BULLETIN NO. 33

JEFFERSON LAB

TECHNICAL ENGINEERING & DEVELOPMENT FACILITY
(TEDF TWO)

Bulletin No.33
Project No. 20080400
March 04, 2011

3 SECTION DETAIL
3" = 1'-0"

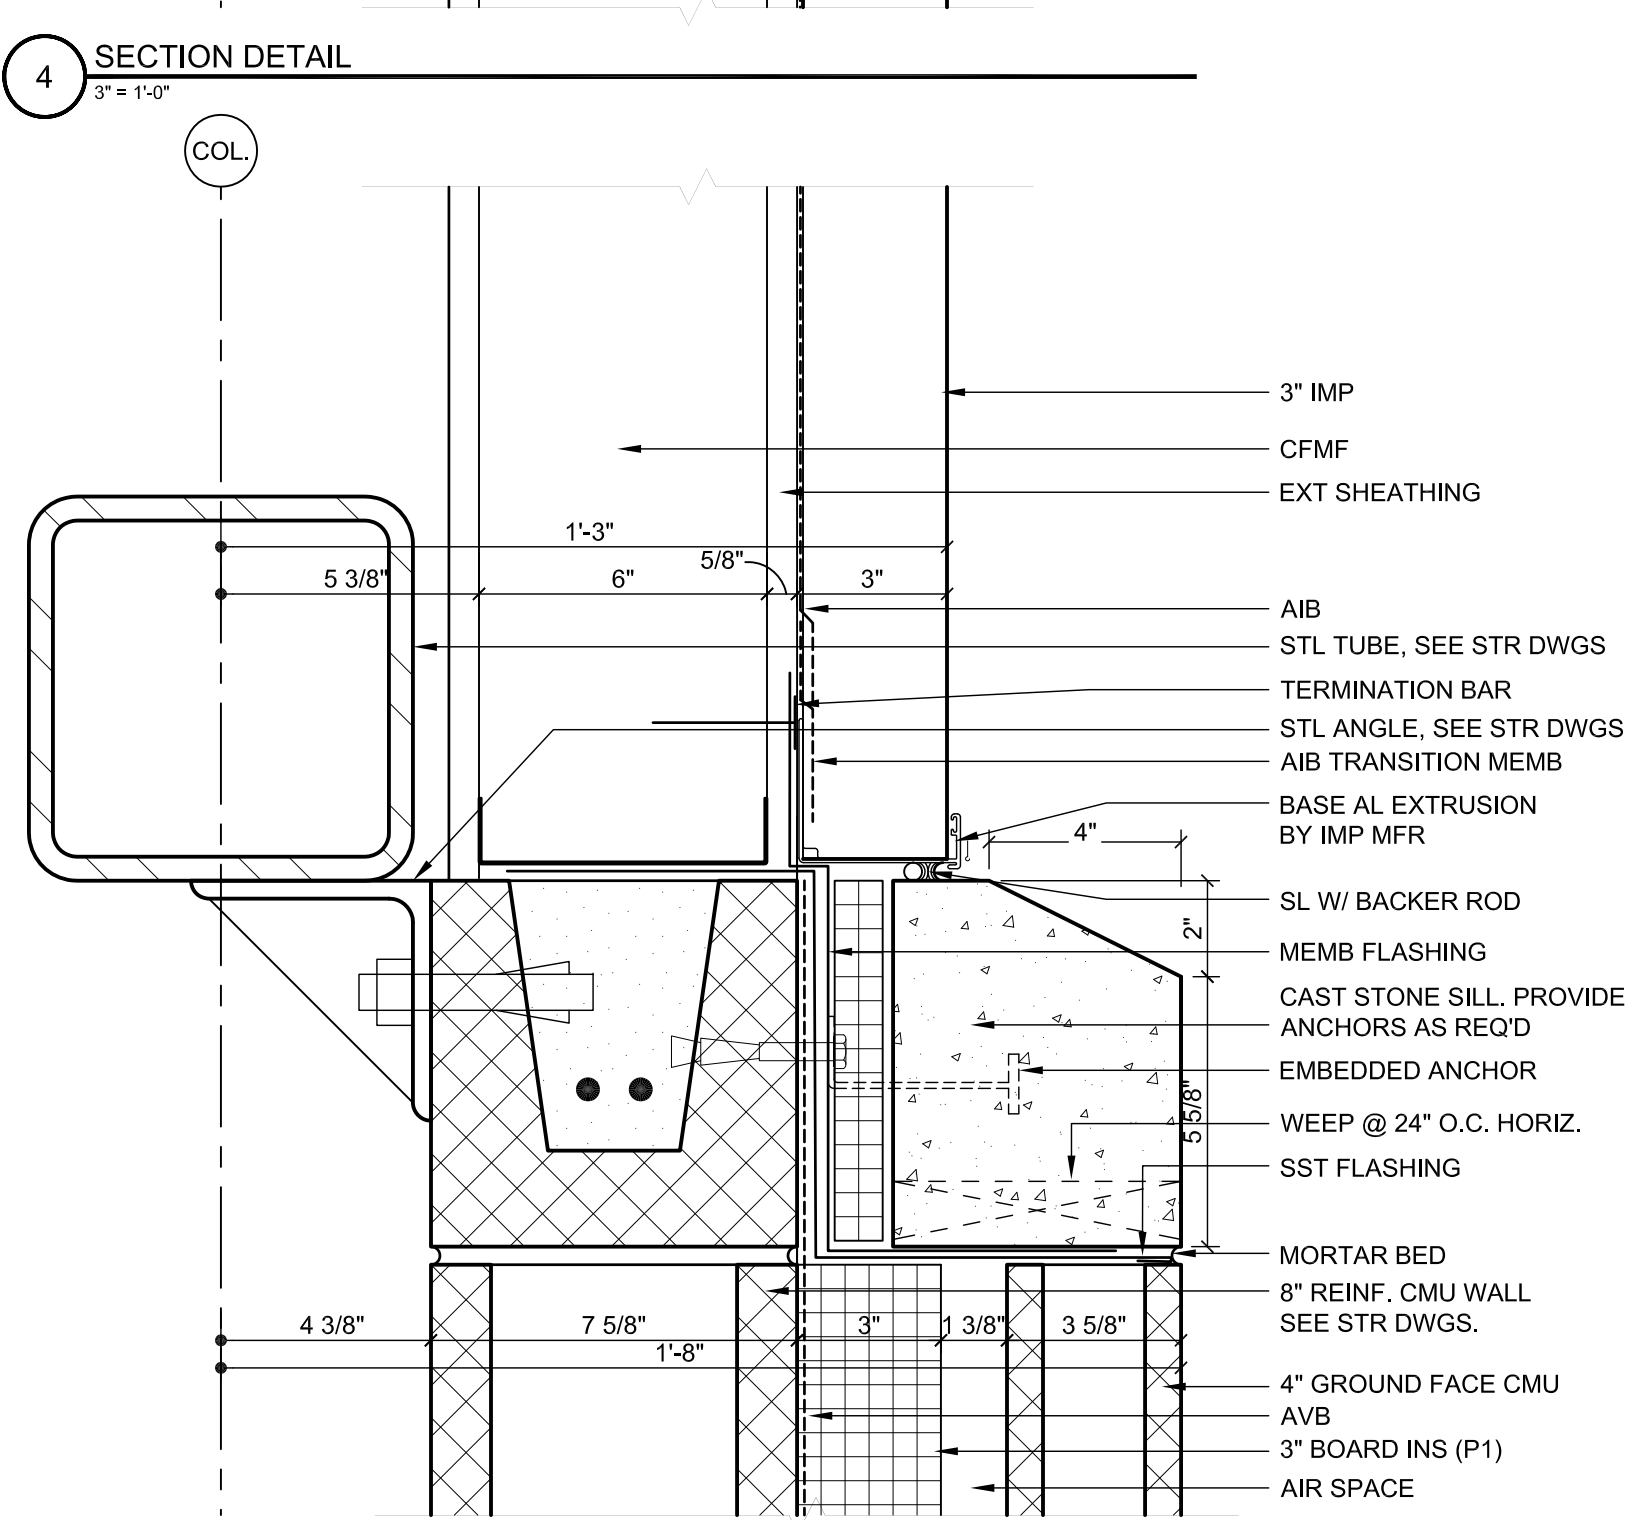
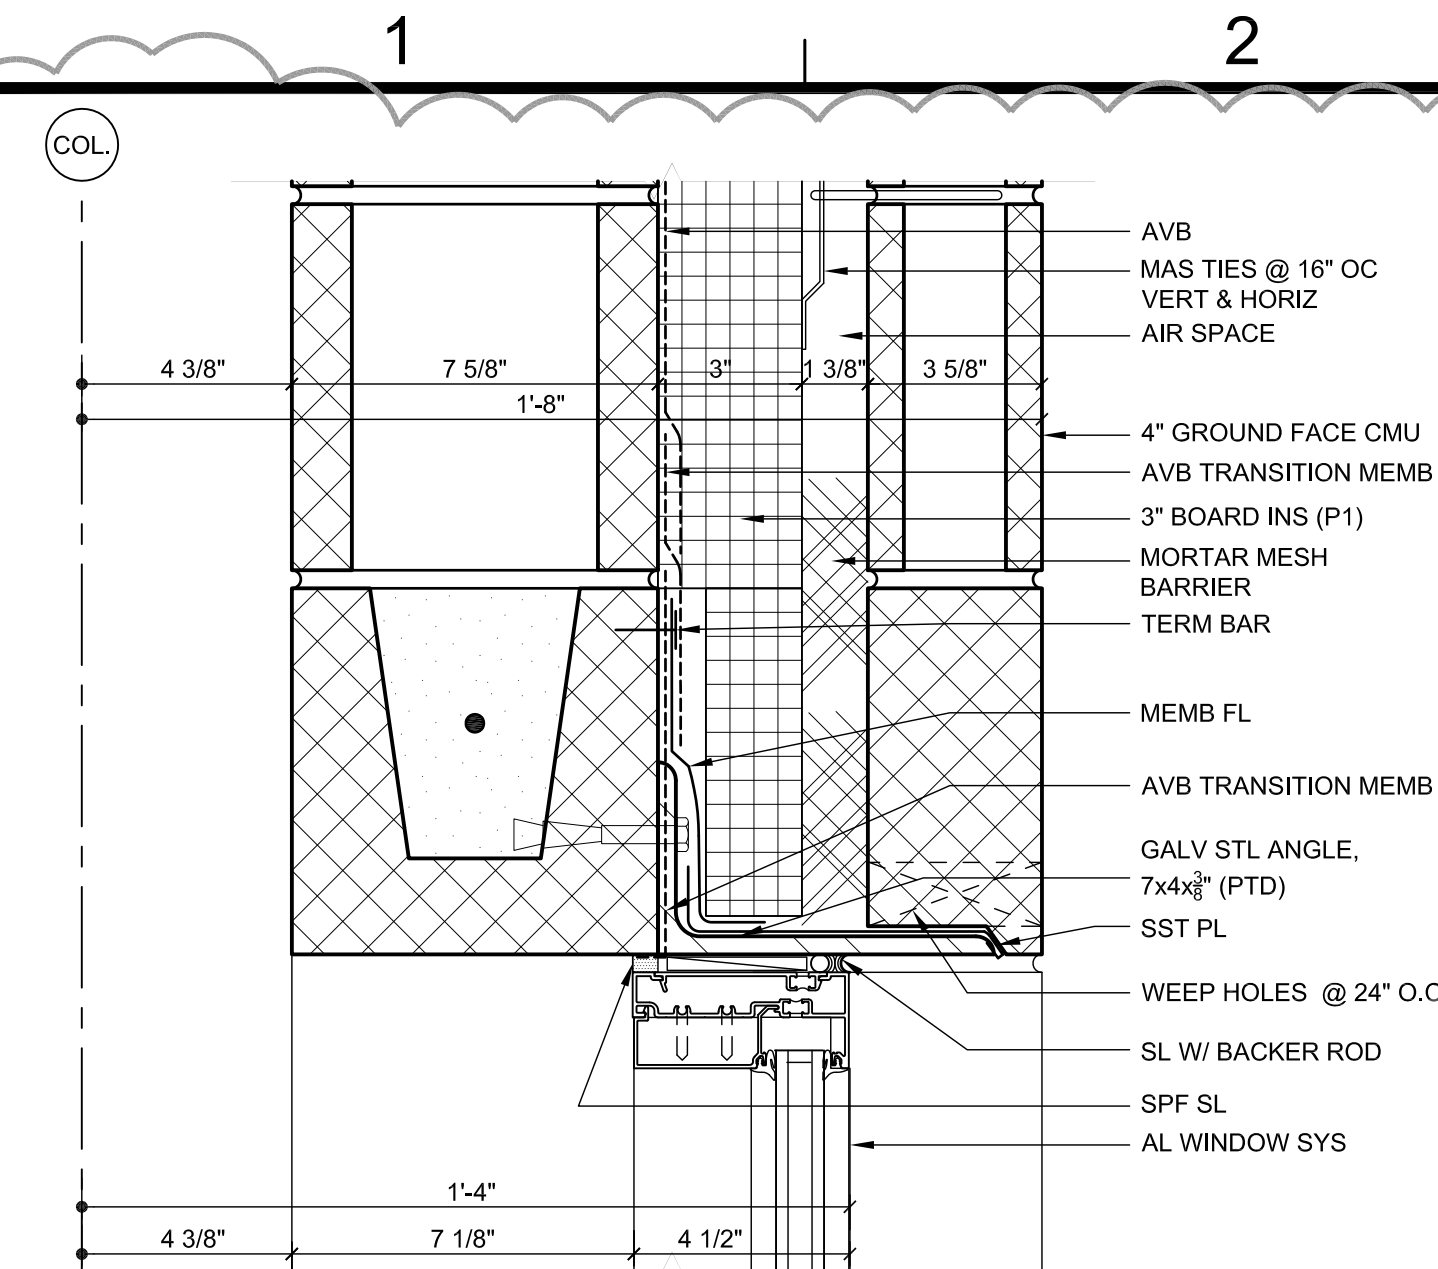
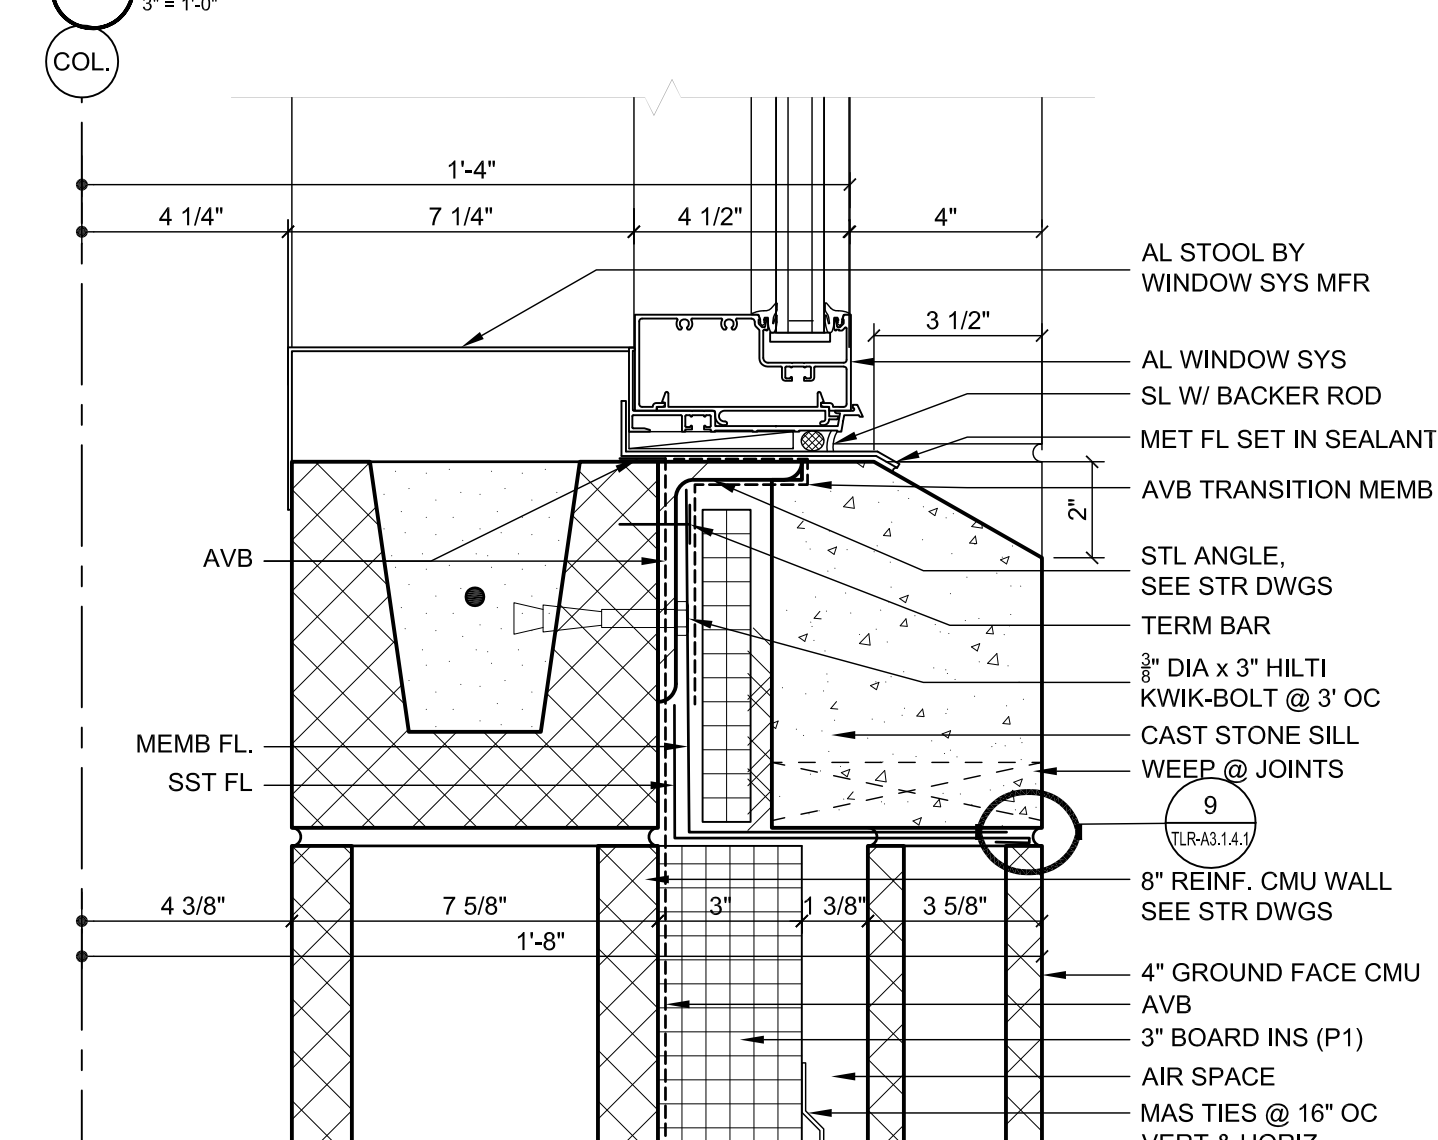
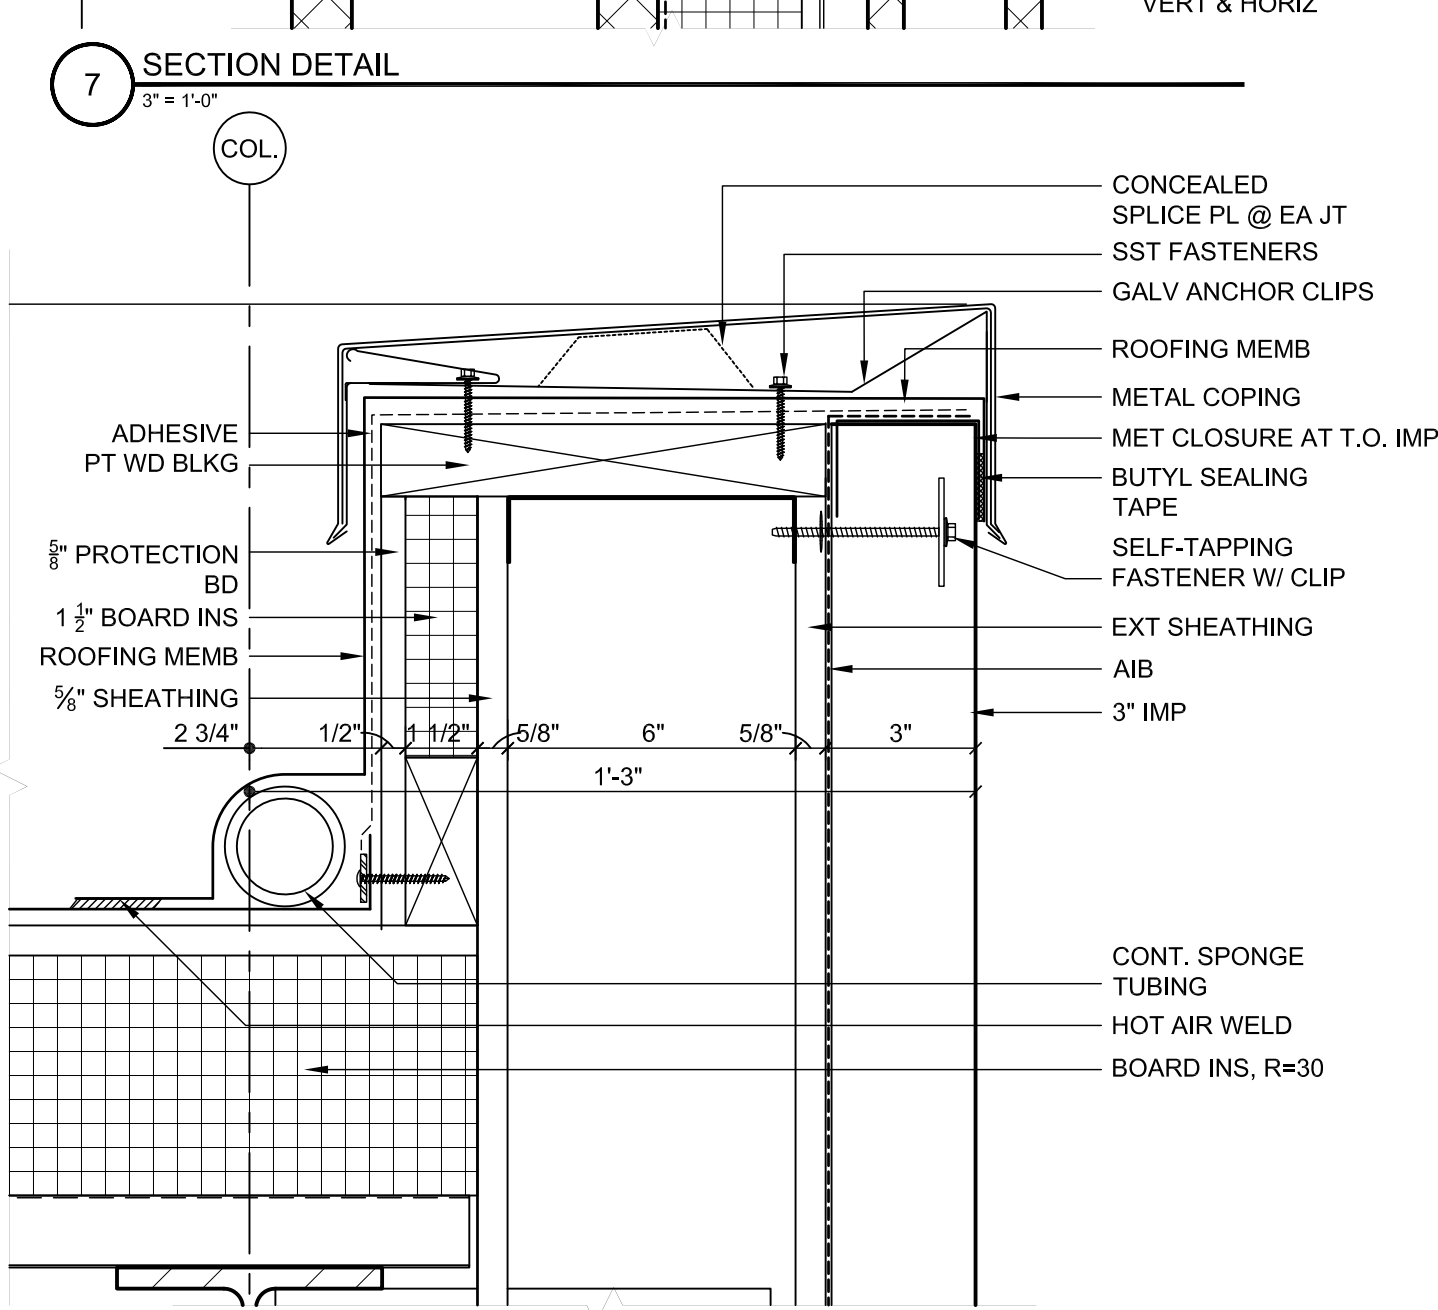
1. Revised section details
